## **Cylinder Head Caution for 2007-2011 GM 2.8, 3.0 & 3.6L High Feature Engines**

The AERA Technical Committee offers the following information regarding a cylinder head caution for 2007-2011 GM 2.8, 3.0 & 3.6L high feature engines. The caution expressed concerns only engines that anticipate cylinder head replacement. Ordering the proper head may save a lot of time and confusion.

**Figure 2. Second Design "Saddle Cap Head" (1)**

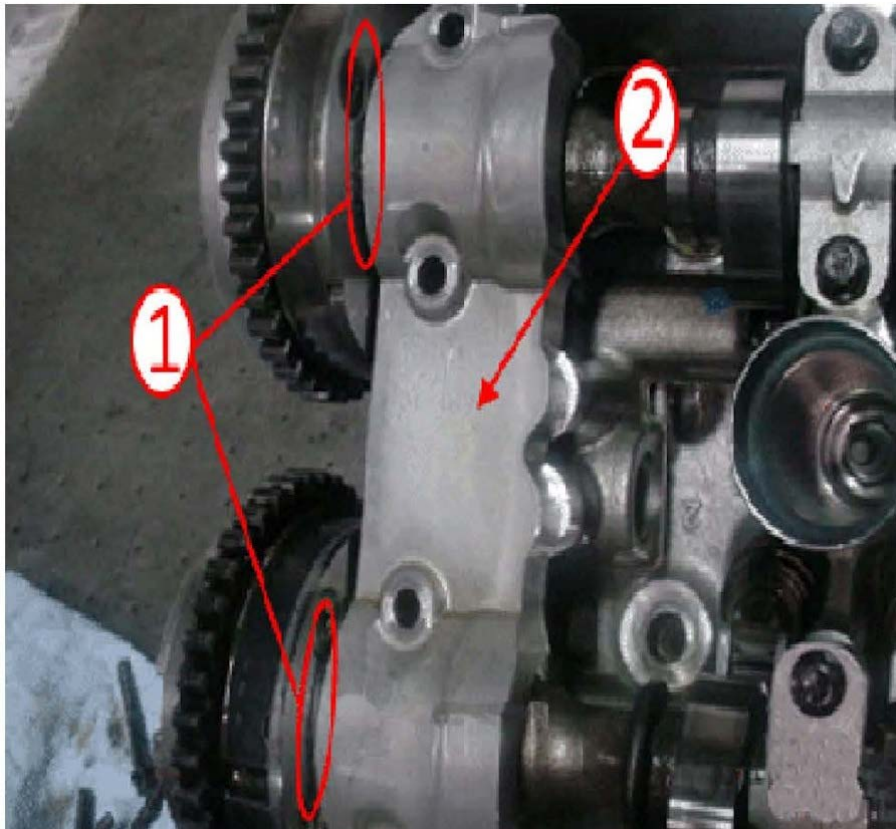
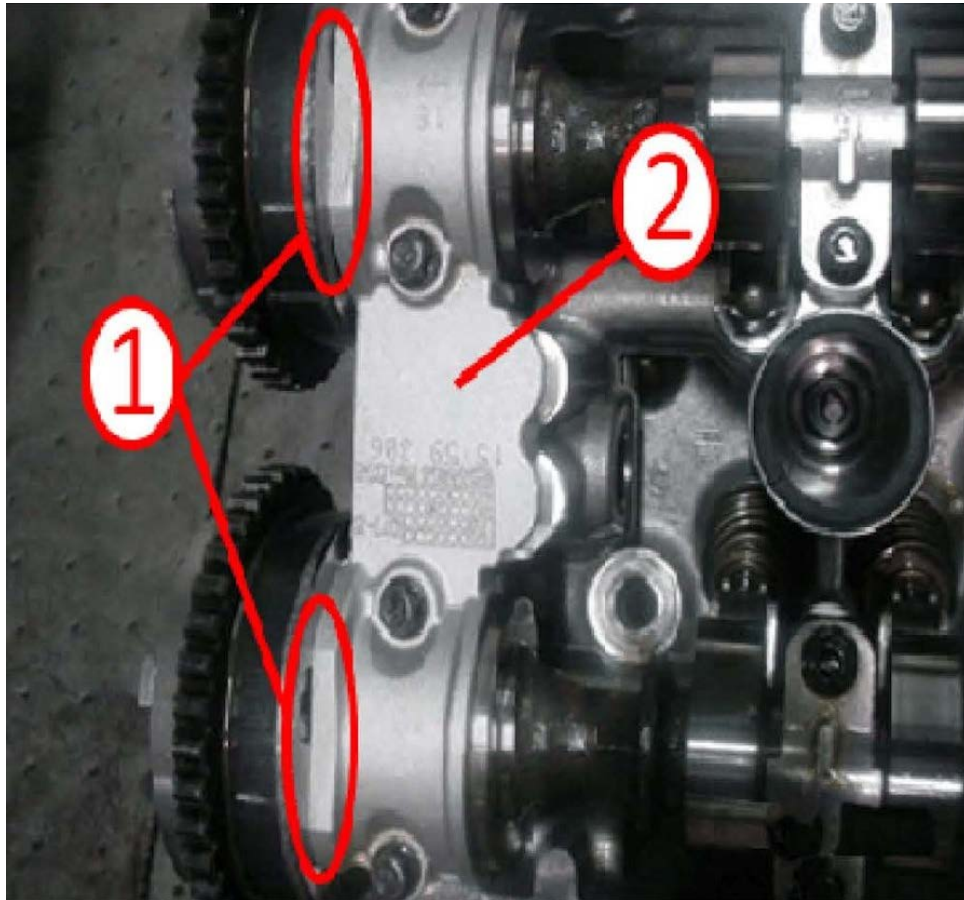
A second design cylinder head was created to ease the assembly process of the cylinder head. This head has eliminated the thrust washers used to limit camshaft end-play. The new head called “Saddle Cap” shown in Figure 2 below should not be used with thrust washers. It should also be noted the second design head will not work properly with 2004-2006 and some early first design 2007 model year engines.

GM also suggests using only the new second design heads for earlier heads suspect to damage caused by the camshaft thrust washers.
